Access Compliance Report

Public Rights-of-Way

(Curb Ramps)

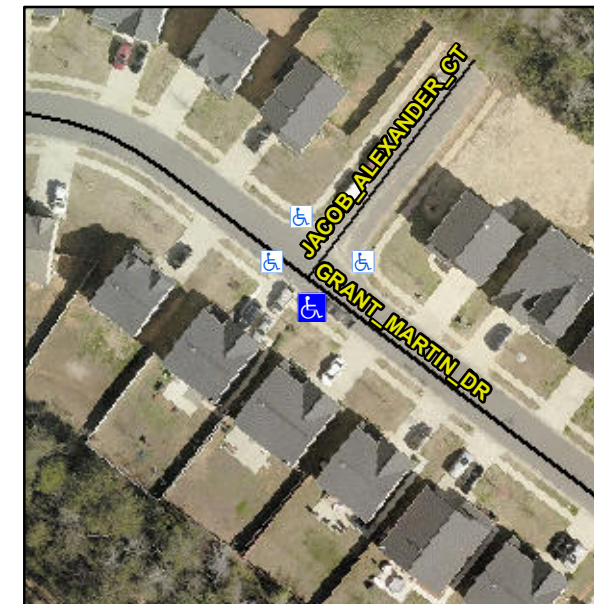
Intersection ID: 53001	Main Street: GRANT_MARTIN_DR	Cross Street: JACOB_ALEXANDER_CT	Location: S
ADA ID: 80CA02B22C82	Ramp Type: Perp	Initial Pass/Fail: Fail	Overall Compliance: No
Severity Score: 10			
Codes/Mitigation Info/Possible Solution		Field Measurements/Component Compliance

Not Found, R304.5.1, R304.5.3

Compliance	Description	Data	Compliance	Description	Data
N/A	Ramp Length (in)	48.0	Yes	Ramp Slope (%)	7.3
No	Ramp Width (in)	47.5	No	Ramp XSlope (%)	2.7
N/A	Flare Type LT	N/A	N/A	Flare Type RT	N/A
N/A	Flare Slope LT (%)	N/A	N/A	Flare Slope RT (%)	N/A
N/A	Flare Traversable LT?	N/A	N/A	Flare Traversable RT?	N/A
N/A	Landing Length (in)	N/A	N/A	DWS Provided?	N/A
N/A	Landing Width (in)	N/A	N/A	DWS Contrast?	N/A
N/A	Landing Slope (%)	N/A	N/A	DWS Length (in)	N/A
N/A	Landing X Slope (%)	N/A	N/A	DWS Full Width?	N/A
N/A	Landing Curb? (Y/N)	N/A	N/A	DWS Offset (in)	N/A
N/A	Shared Landing?	N/A			
N/A	Gutter Ponding?	N/A	N/A	Gutter Slope (%)	N/A
N/A	Gutter Lip Ht (in)	N/A	N/A	Gutter X Slope (%)	N/A
N/A	Painted X Walk1?	No	N/A	Painted X Walk2?	N/A
	X Walk 1 Direction	To NE		X Walk 2 Direction	N/A
N/A	X Walk 1 Width (in)	N/A	N/A	X Walk 2 Width (in)	N/A
	X Walk 1 Slope (%)	2.6		X Walk 2 Slope (%)	N/A
	X Walk 1 X Slope (%)	1.9		X Walk 2 X Slope (%)	N/A

Remove & Replace Entire Ramp.
